Evaluation of Ecological Impact Assessment (EcIA) and BNG
Habitat Management & Monitoring Plan (BNG/HMMP)
Land North of Colwell Farm, Haywards Heath

EcIA & BNG/HMMP Analysis

Figure 1: Historical Nightingale reporting rate in West Sussex by month (Birdtrack.net)

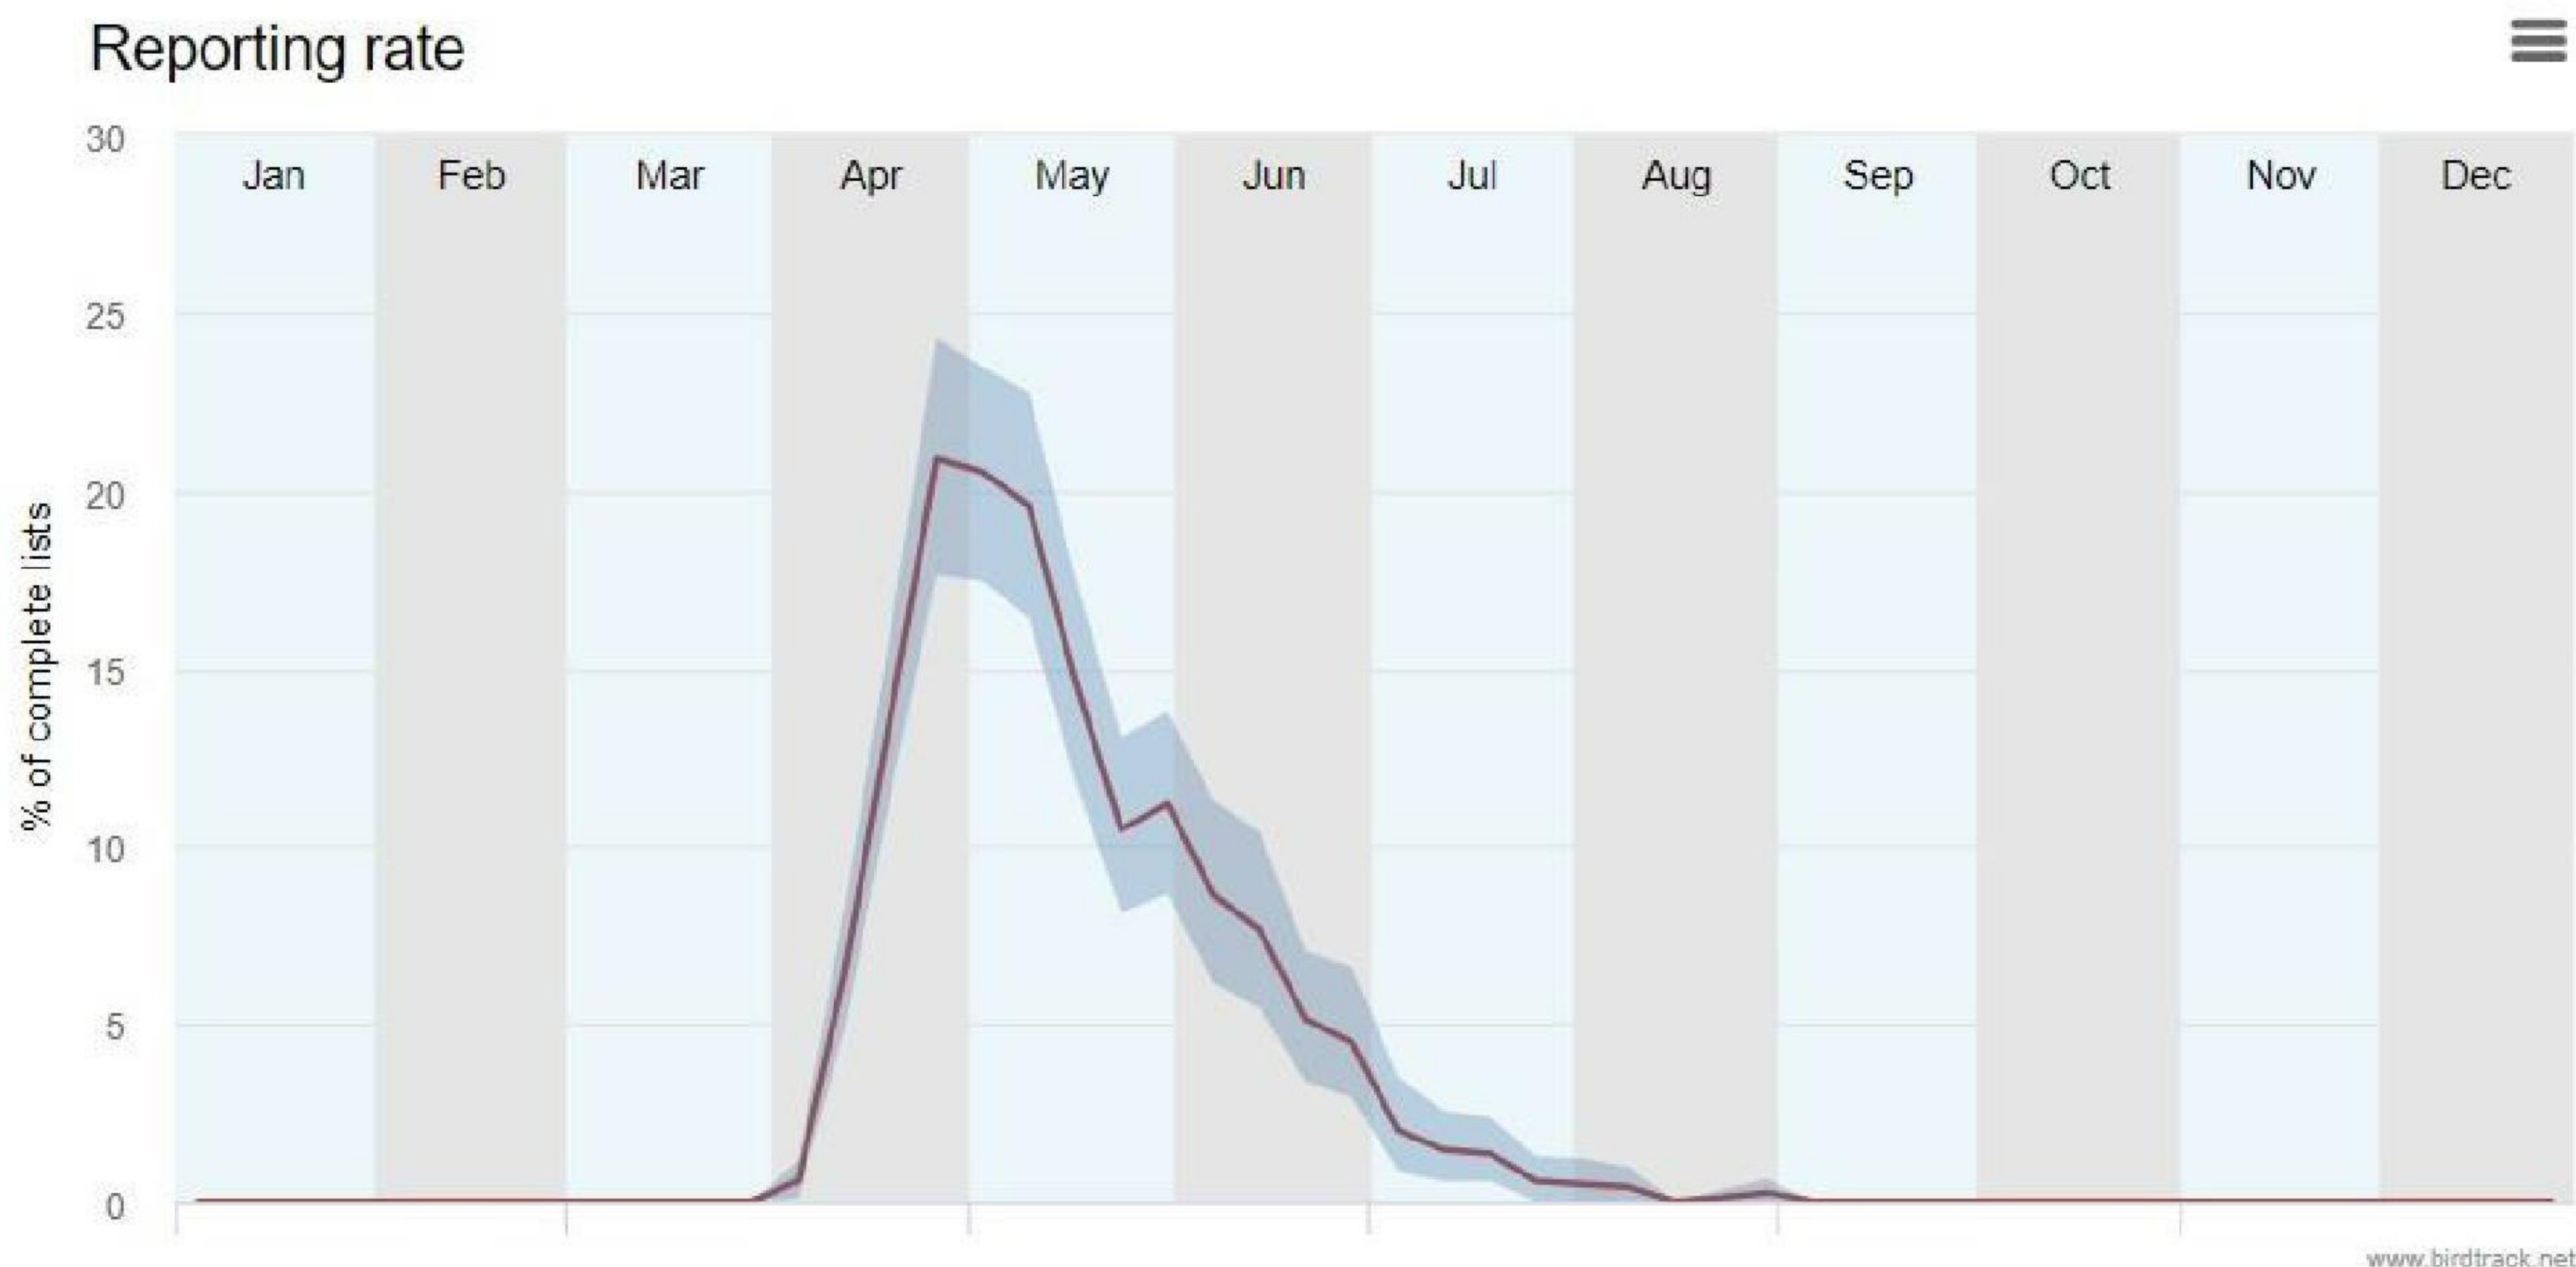
It is also possible the survey missed rare birds, such as Nightingale, which is generally only reported over a short period between the end of April and mid May (see Figure below). The NBN Atlas²⁰ indicates 18 records of Nightingale within a 2km radius, so it is possible Nightingale are on the site.
